City of Puyallup
Development & Permitting Services
ISSUED PERMIT

PUYALLUP PUBLIC SAFETY BUILDING: BENAROYA TENANT IMPROVEMENT

Permit/Bid Set – March 4, 2025

A PORTION OF THE NE 1/4, SE 1/4, NW 1/4 & SW 1/4, OF THE SE 1/4 OF SEC. 3,TWN. 19 N, RGE. 4 E, W.M. CITY OF PUYALLUP, PIERCE COUNTY, WASHINGTON

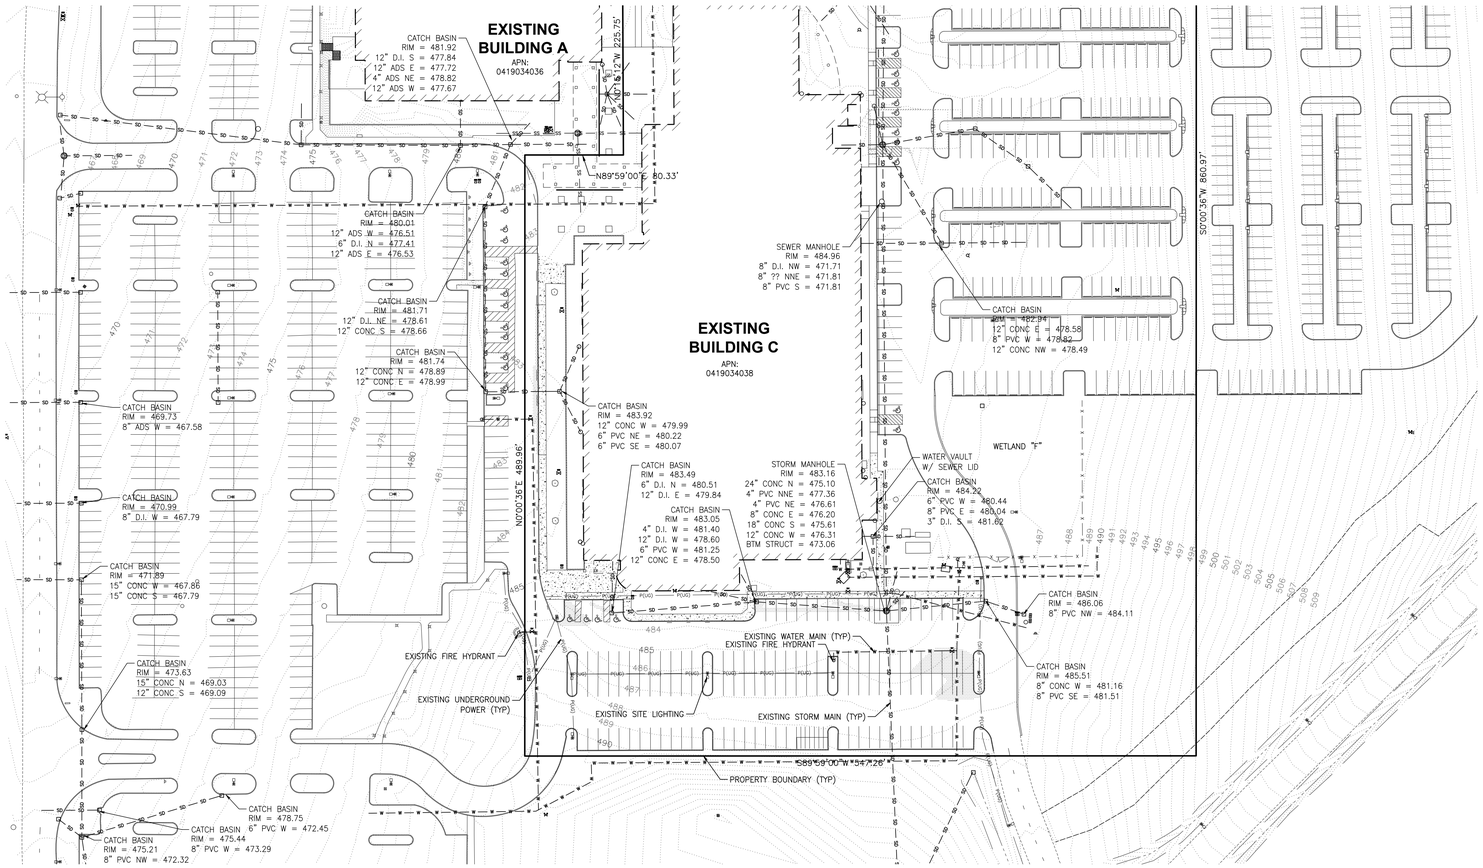
PRCTI20250324 shall match approved civil permit PRCCP20250372

For Reference Only
See separate civil permit.
PRCCP20250372

PARTIAL FIRST FLOOR PLAN - AREA A
1/8" = 1'-0"

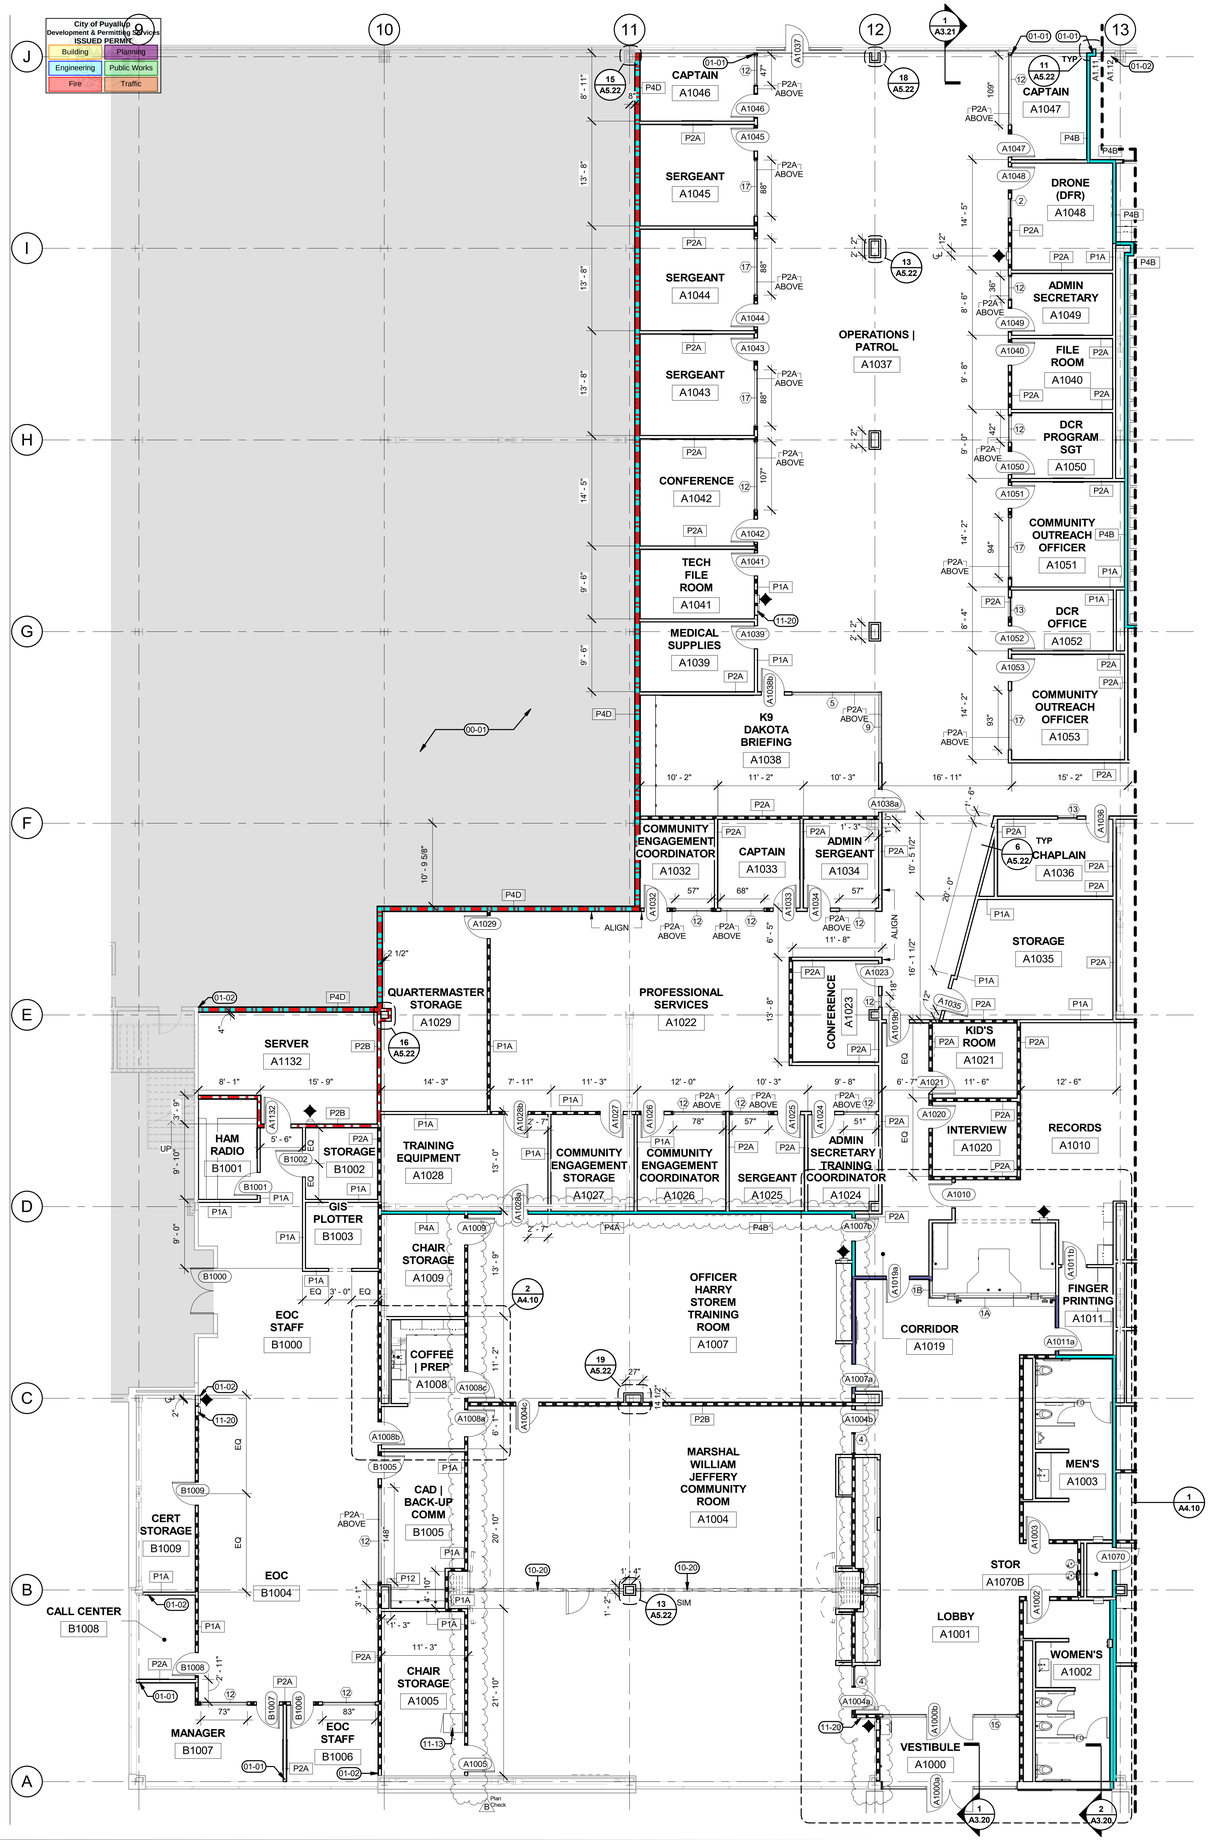
Fire rated penetrations (typical)
See project specification sections 26 00 00, 3.09 and 26 05 33, 3.08D
Provide manufactures installation information for inspection.
